City of Carpinteria
Architectural Review Board Agenda
Thursday, March 26, 2026
Council Chamber, 5775 Carpinteria Avenue,
Carpinteria, CA 93013

**CITY OF CARPINTERIA
ARCHITECTURAL REVIEW BOARD
Meeting of March 26, 2026**

Project: 25-2372-CDP/ARB **Planner:** Bret McNulty
Address: 5538 Canalino Drive
APN: 003-382-012
Zoning: Single Family Residential (6-R-1)
Applicant: Robert Mahterian, architect, for Keith and Lesley Marvin

Existing Single Family Residence Remodel
5583 Canalino Drive
Project #25-2372-CDP/ARB
Preliminary ARB Review
March 26, 2026

NEW SITE PLAN

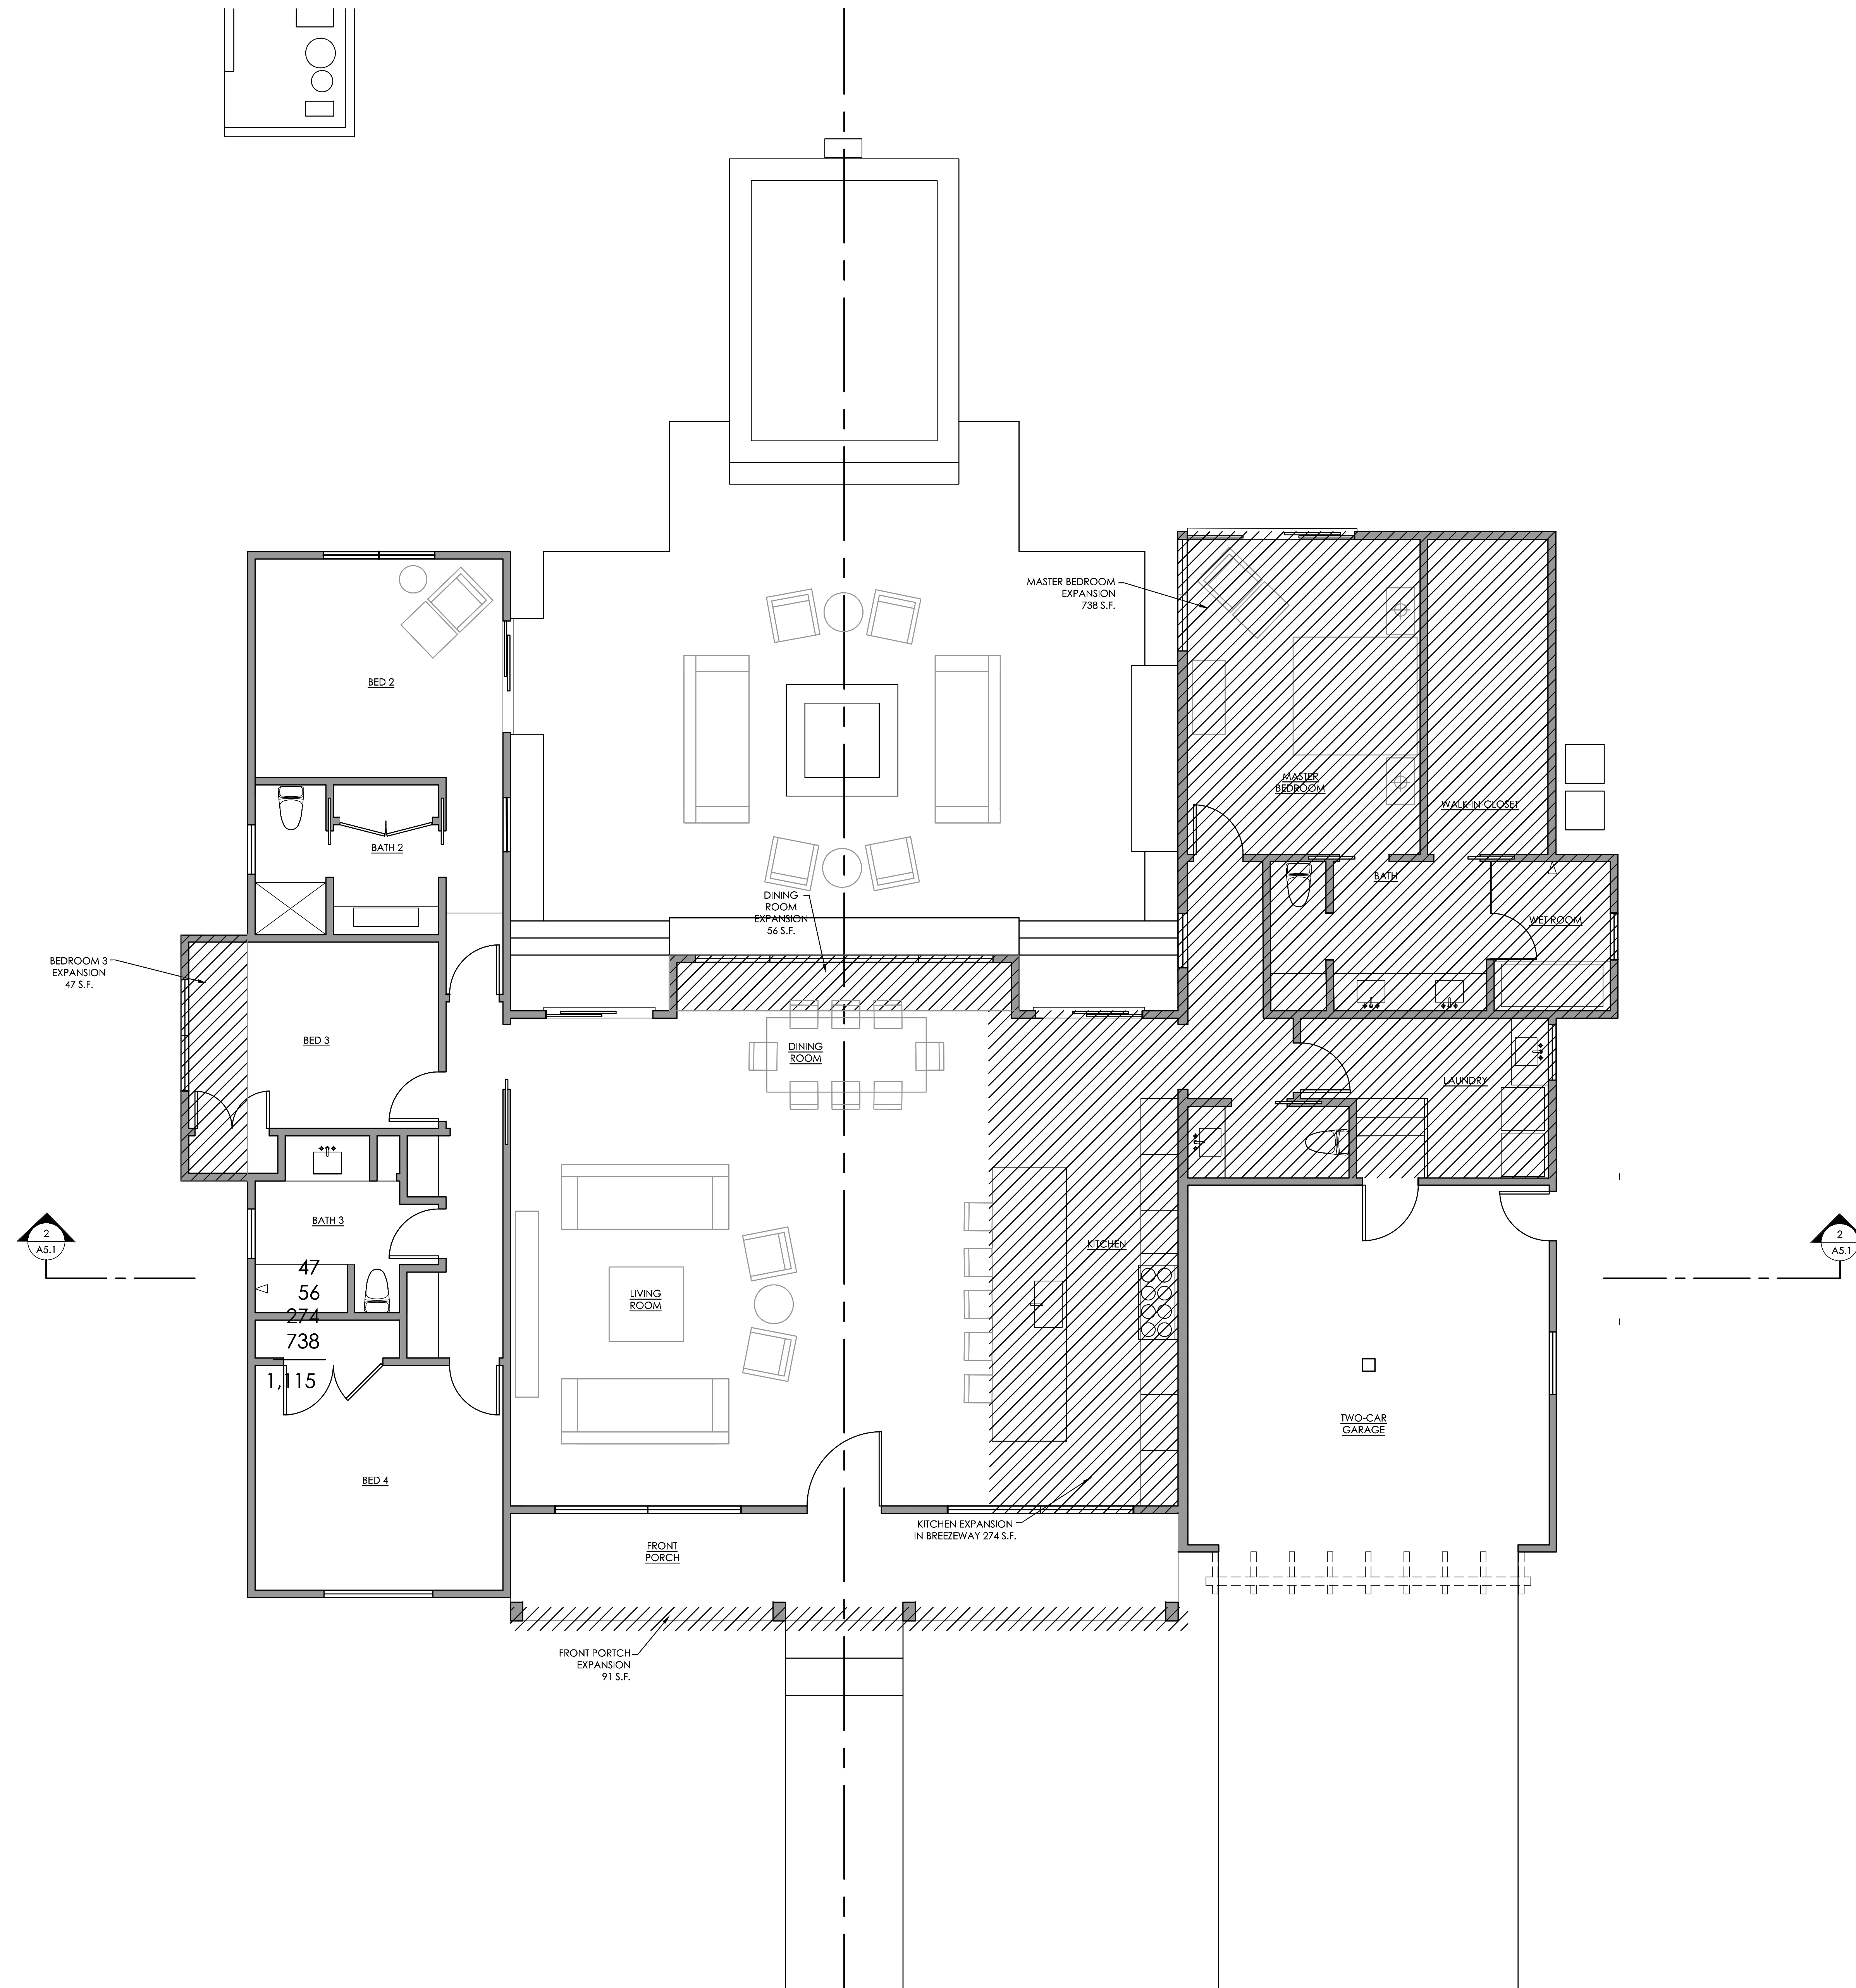
The preliminary plans show the proposed new aggregate concrete driveway off of Canalino Drive as having a width of 16-feet 1 ¼ inches with an area of 466 square feet. The existing driveway is approximately 21 feet wide with an area of 600 square feet. In other words, the proposed driveway would result in an overall reduction of front yard paving. CMC §2.36.050.C and §2.36.130.D strive

to limit driveways to no more than 324 square feet of contiguous paved area within a front yard to avoid “excessive paving.” In this case, most of the excess paving appears to be a result of the larger than normal front setback, resulting in a longer than usual driveway. The Board should review the proposed driveway dimensions and consider whether the proposed driveway should be redesigned to: 1) reduce the width to 16-feet or less, and/or 2) reduce the impervious square footage of the driveway by incorporating permeable pavers and/or a landscaped “ribbon” to reduce the amount of paved area to 324 square-feet or less. Alternatively, if the Board is supportive of the driveway as shown, they may recommend approval to the Director.
